NOTICE OF A TYPE II DECISION ON A PROPOSAL IN YOUR NEIGHBORHOOD

CASE FILE NUMBER: LU 20-198076 HR - SOLAR ARRAY

The applicant proposes a new solar energy system at an existing contributing resource in the Alphabet Historic District to include 26 panels attached to the east- and west-facing slopes of the roof as well as a utility meter and AC disconnect on the east façade of the house (not shown in the drawings). Per the information provided the panels are noted to be set off the roof at a distance "<18 inches". Please note the dimensions shown in the attached site plan are not accurate.

LU 20-198076 HR C-002

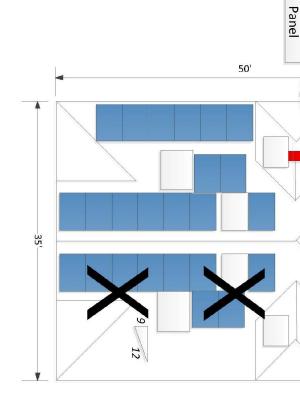
Utility Meter Disconnect AC *See Condition E

*See Condition D

- C. No field changes allowed.
- D. The solar array shall be limited to the west slopes of the roof and the final layout shall meet Fire Bureau requirements.

- E. The AC Disconnect switchbox shall be attached within the field of siding immediately adjacent to the existing meters and shall not overlap and trim elements.
